TECHNICAL NOTE

from:	[REDACTED]	date:	16/2/2022
subject:	3/2020/0911. Shackletons Garden Centre Ltd Clitheroe Road Chatburn BB7 4JY, Proposed two-storey extension Including additional indoor and outdoor retail space and increased cafe area and play area.	file ref:	J1168-TN1

This Technical Note sets out the response to the feedback.

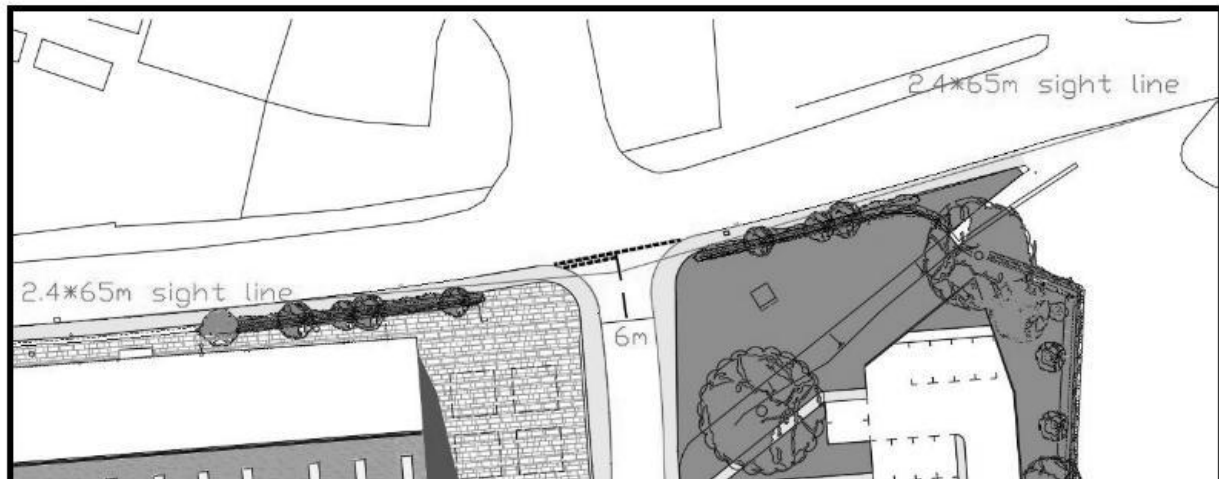
The LHA have reviewed the revised site plan provided by Stanton Andrews and understands that the width of the proposed access will be approximately 10m wide adjacent to the public highway. This will be reduced to an internal carriageway width of approximately 6.2m, a distance of 18m from the public highway.

The width of the proposed access complies with the LHAs guidance which requires an access serving a Garden Centre to be 6m wide for a total distance of 10m behind the highway boundary.

Noted and taken on board as part of the access review below.

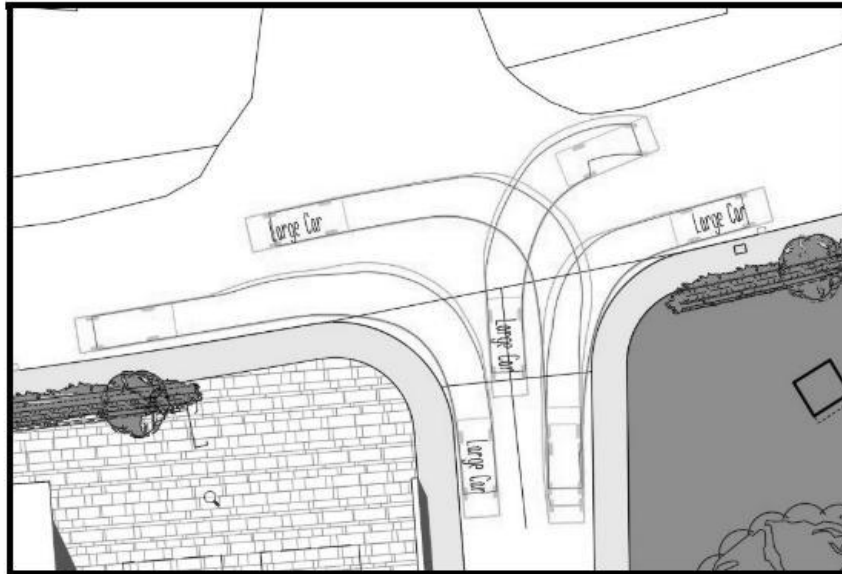
The LHA also have concerns associated with the site entrance/exit having 3 lanes as shown on the drawing. This is because the width of the carriageway which is approximately 6.2m wide, is extremely narrow to incorporate 3 lanes. Therefore, the LHA are concerned that due to the carriageway being narrow that conflicts could occur between vehicles manoeuvring into the correct lane.

The road width was designed to accommodate 2 out and 1 in for cars only to the car park with a width ranging from 6.2m to over 8m

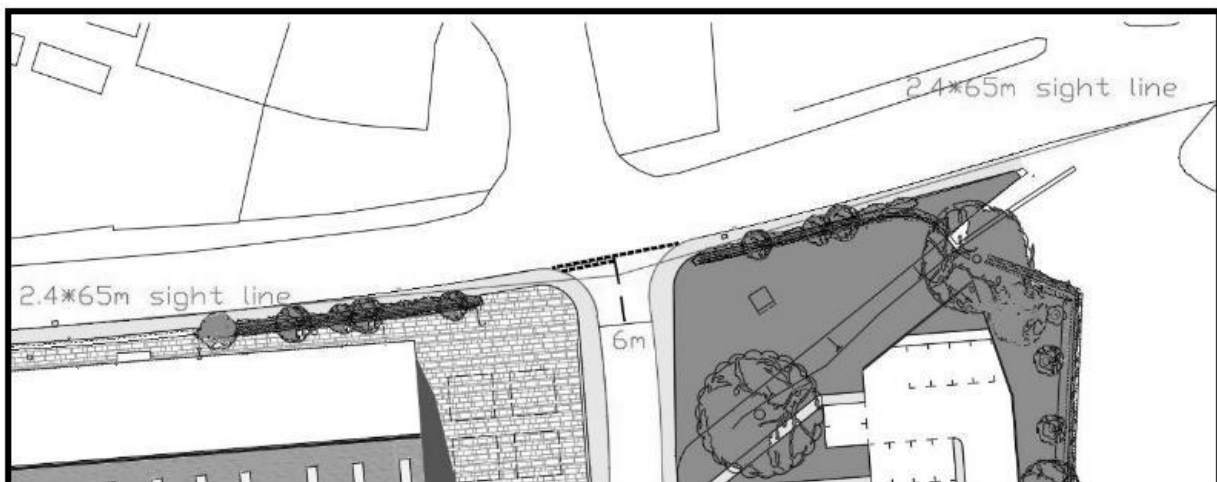
Not only this but the LHA are concerned that vehicular visibility for vehicles using the left lane will be skewed when vehicles are using the right lane when exiting the site. This is because the vehicle in the right lane will be blocking the view which could cause conflicts to occur should vehicles in the left lane guess when the road is clear. This would be to the detriment of highway safety.

Therefore, the LHA advise that only two lanes are used at the site entrance/exist. This should be shown along with the relocation of the site access on a revised drawing

The new entrance off Clitheroe Road should also be widened to allow 1x in lane and 2x out lanes i.e. 1 left turn out 1 right turn out. Thorough sweptpath analysis should also be provided to prove both of the access points and carparks safe accessibility.

As stated above the change to a flared access was in response to a highway request set out in the 11/12/2020 pre app reply.

No concerns were raised regarding the junction location.

That said the junction with the centre line and markings shown as below delivers the access in a simpler form with a 6m width.

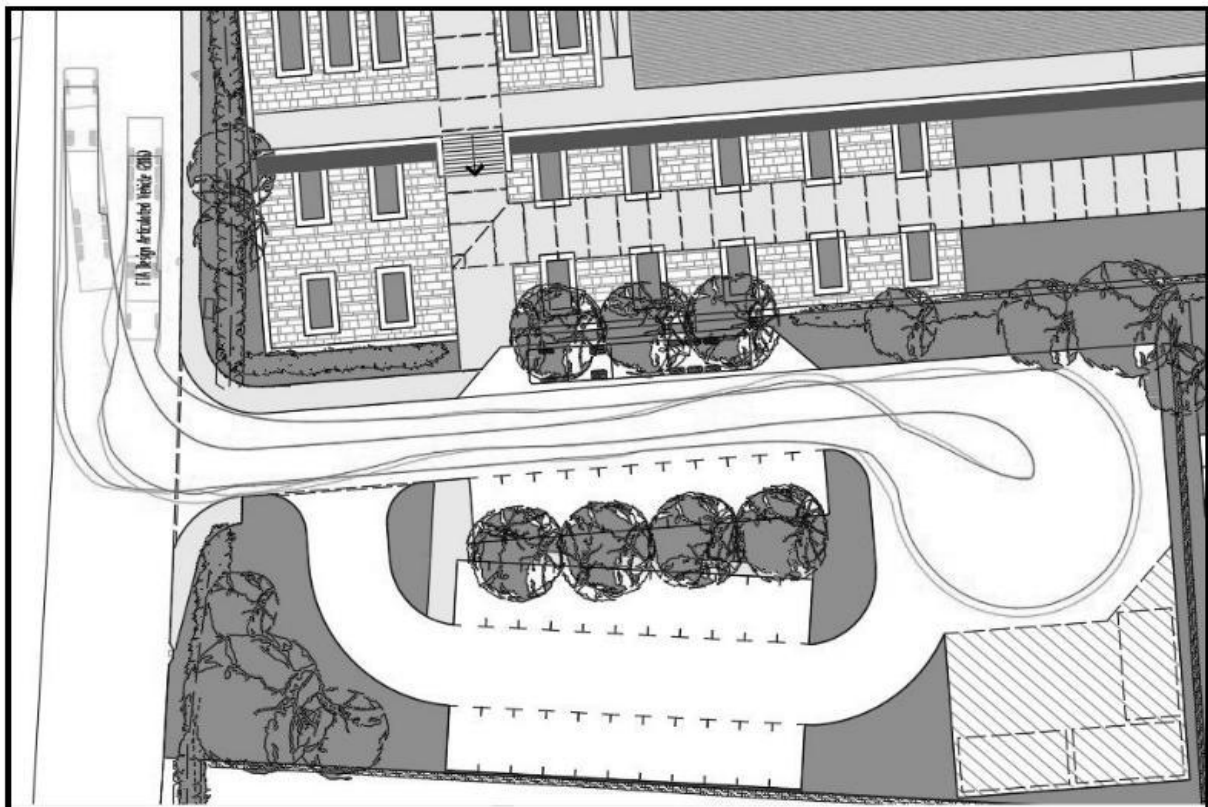
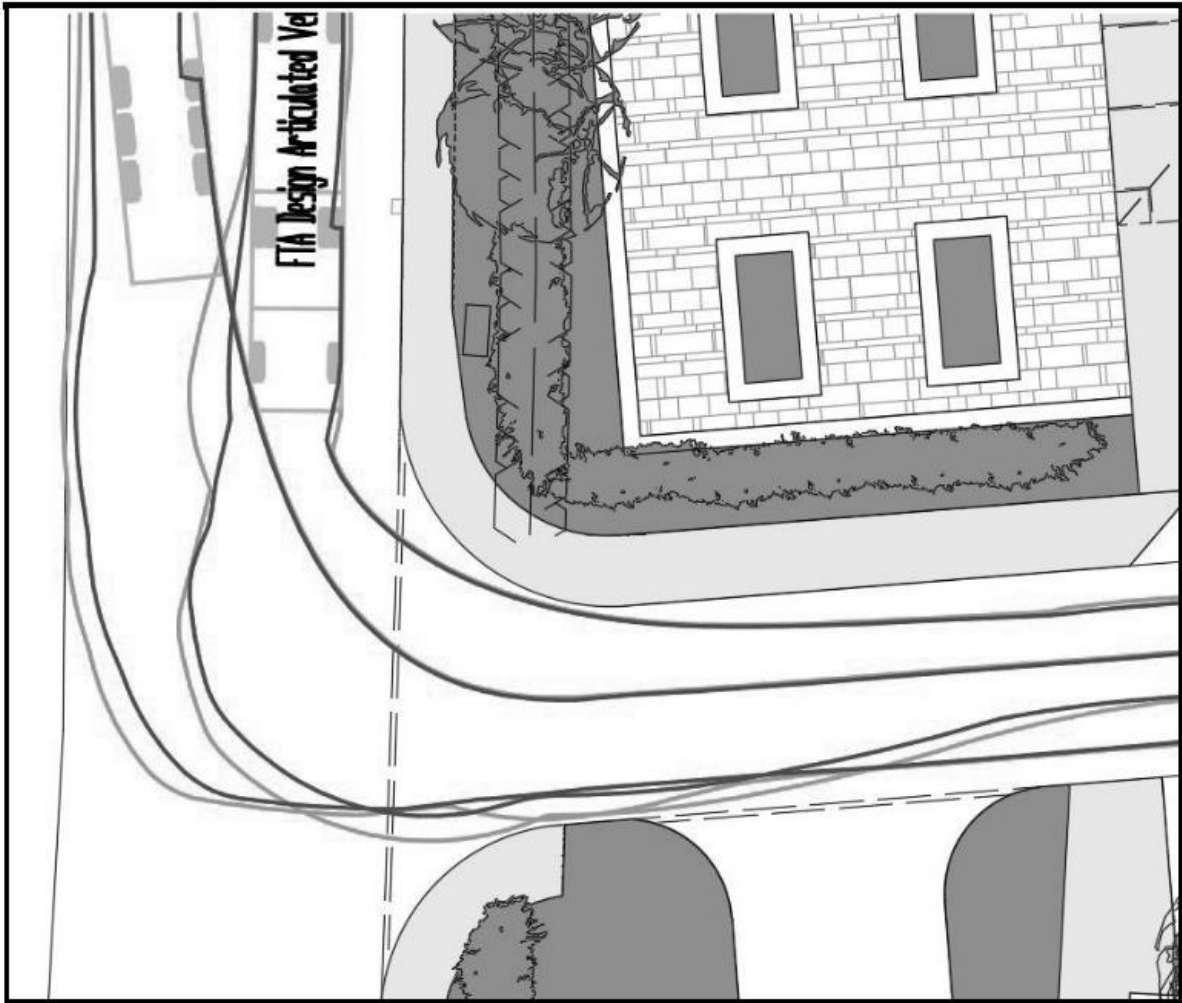
While the LHA have reviewed the drawing and the access arrangements along with the visibility splays comply with the LHAs guidance, the LHA are concerned about large delivery vehicles using the access. This is because as shown on the swept path analysis drawing on the revised plan, the delivery vehicle exiting the site and turning right onto Worston Road, overlaps the grass verge and then the footway as it exits the site.

The drawing also shows its extremely narrow for delivery vehicles to enter the site, with the swept path being extremely close to the footway. Therefore, the LHA require the access and the carriageway into the site to be widened which should be shown on a revised drawing. A revised swept path analysis drawing should also be submitted.

The paths have been updated to show the turn can take place with no overlaps, it should be noted that the green lines indicate the edge of the vehicle body and the redlines the track of the wheels.

name
proposed site plan

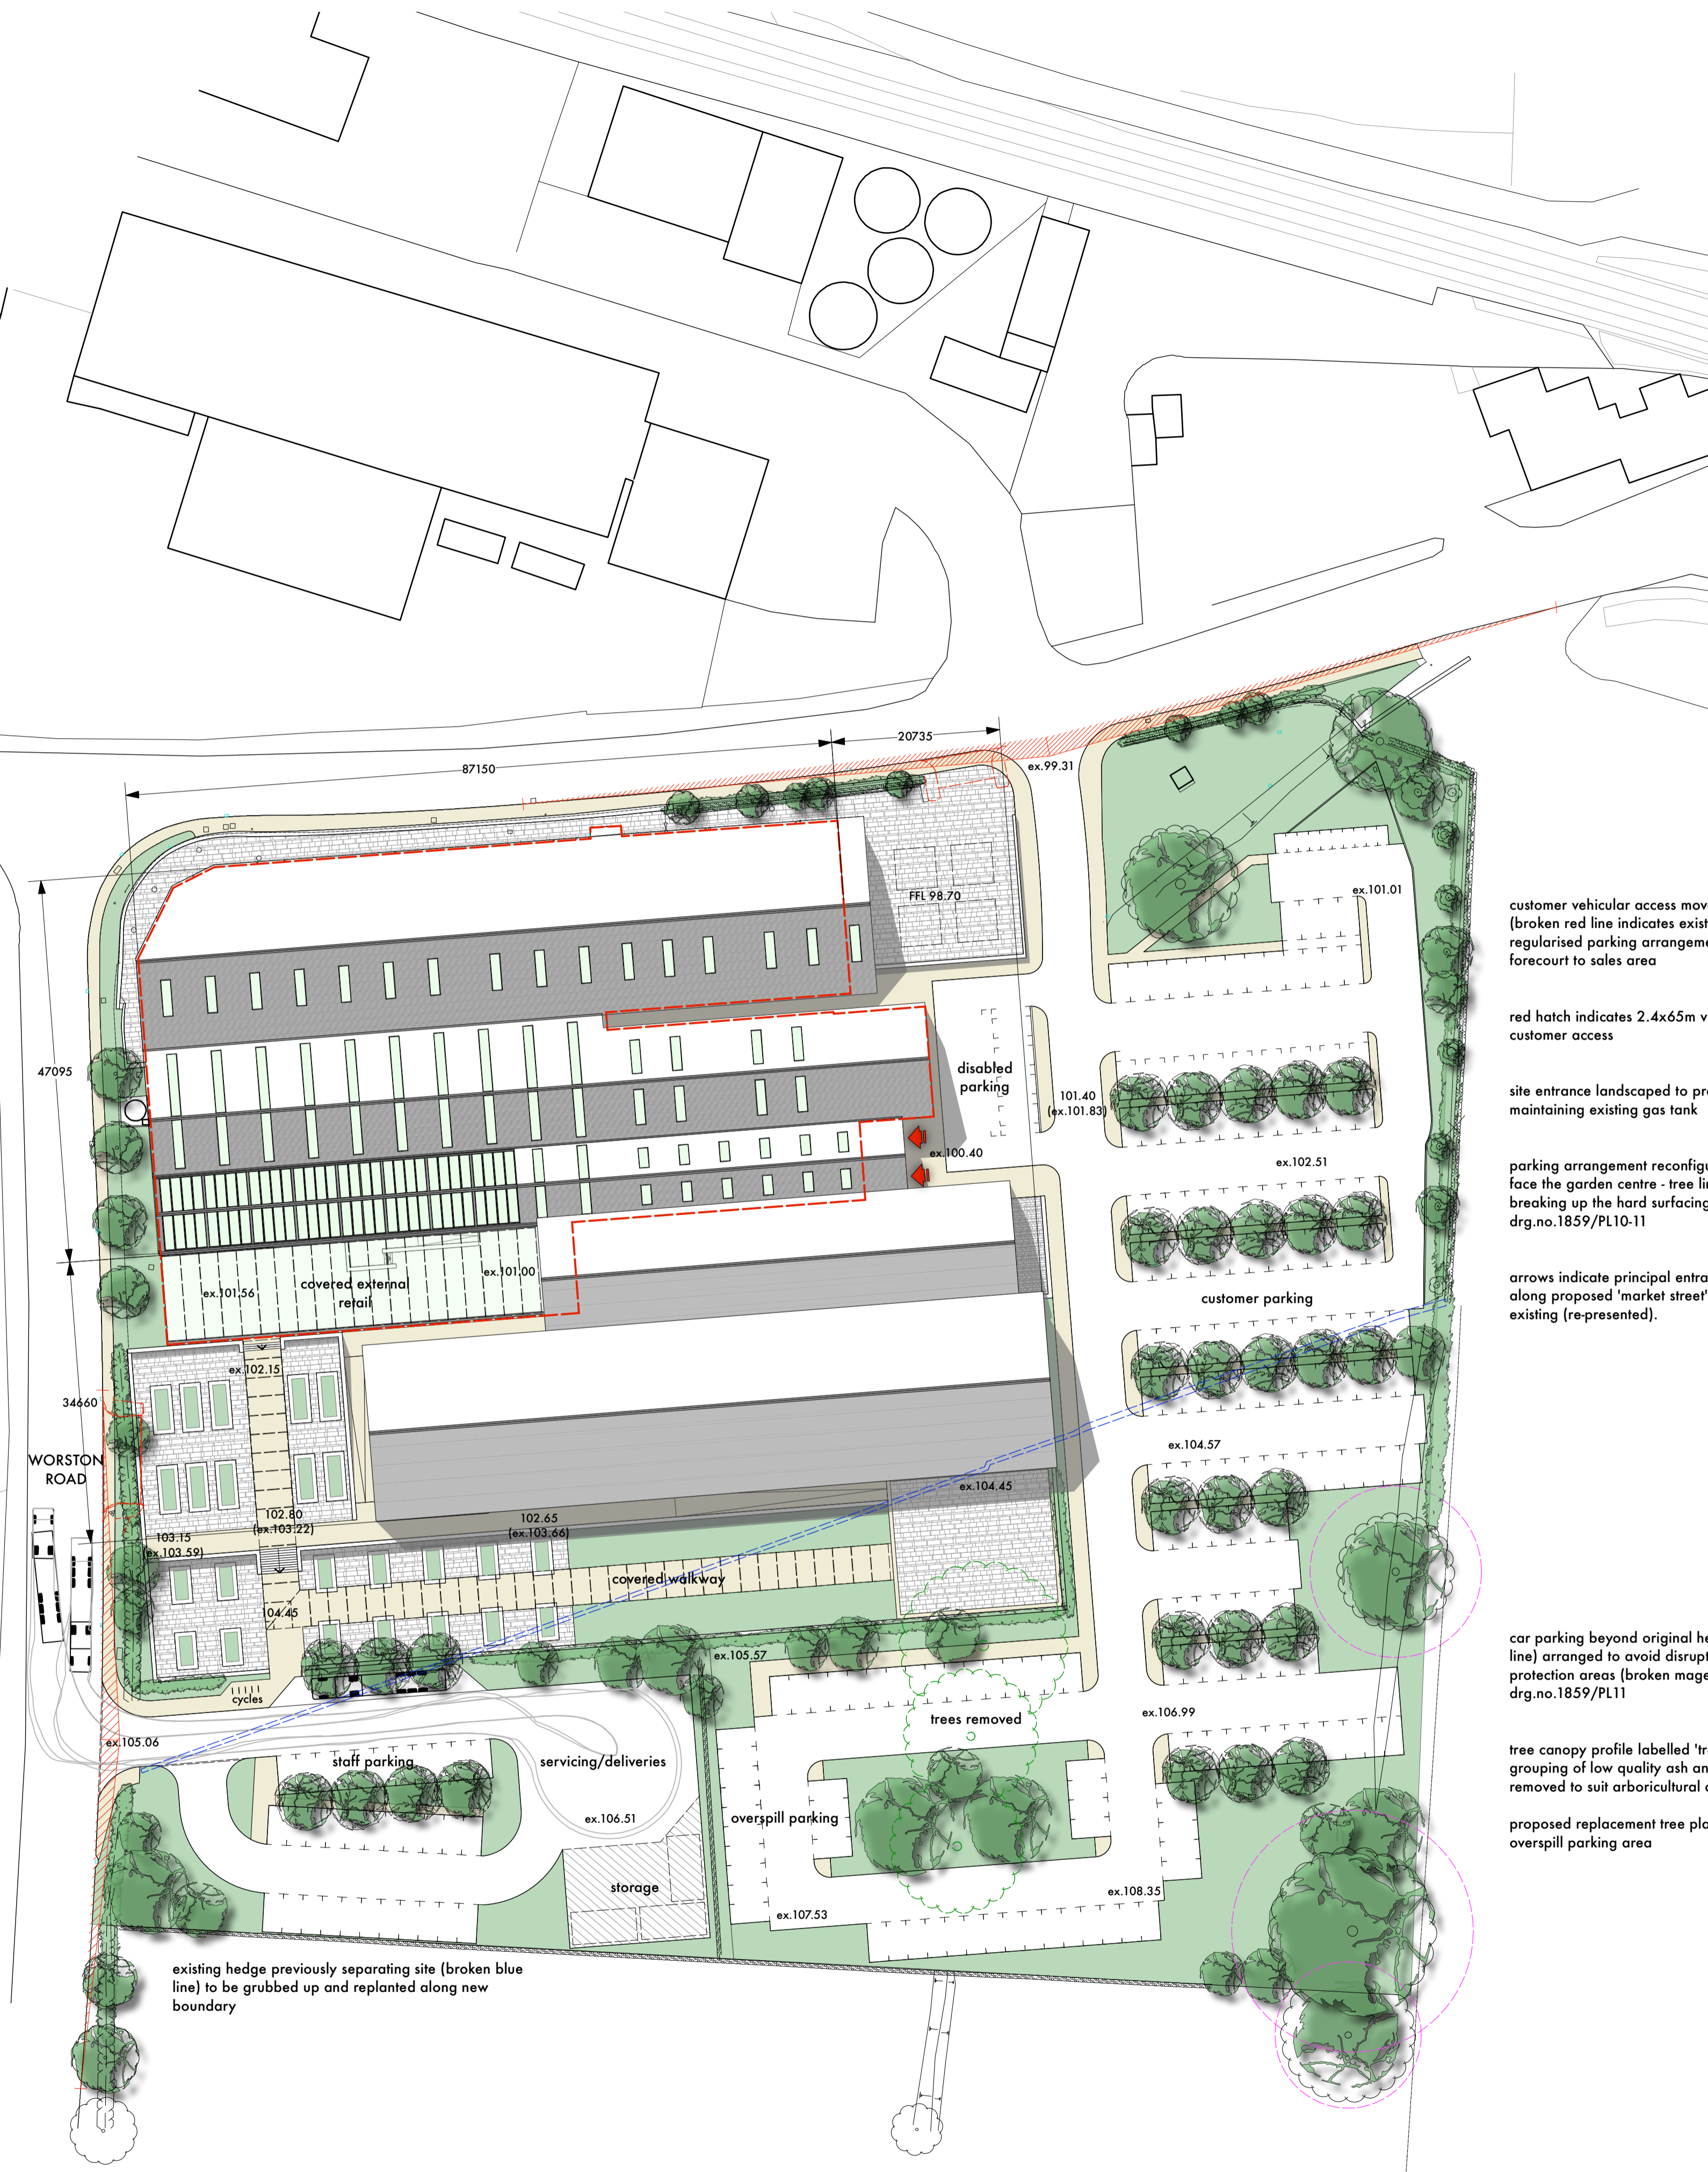
The LHA have reviewed Stanton Andrews drawing number PL.01 Rev D titled "Proposed Site Plan," and understands that following the extension to the existing Garden Centre both accesses will be relocated.

The LHA have also reviewed the visibility splays shown at the proposed access off Clitheroe Road and understands that the site can provide visibility splays of 2.4m x 43m in both directions.

However, the visibility splays shown on the drawing do not comply with the LHAs guidance for a 40mph road. Instead, the LHA require minimum visibility splays of 2.4m x 65m to be

provided at the site to comply with the LHAs guidance found in Lancashire's "Creating Civilised Streets" document.

The LHA would require secure and undercover cycle facilities to be provided at the secondary access located off Worston Road so that staff members have access to cycle spaces as well. This should be shown on a revised plan.

staff and servicing/delivery access moved along worston road (broken red line indicates existing) to suit proposed extensions to garden centre

red hatch indicates 2.4x43m visibility splays to staff/servicing access

5 no. staff cycle bays (10 spaces) added to staff/servicing entrance area to suit highways advice

customer vehicular access moved along clitheroe road (broken red line indicates existing) providing regularised parking arrangement and additional forecourt to sales area

red hatch indicates 2.4x65m visibility splays to customer access
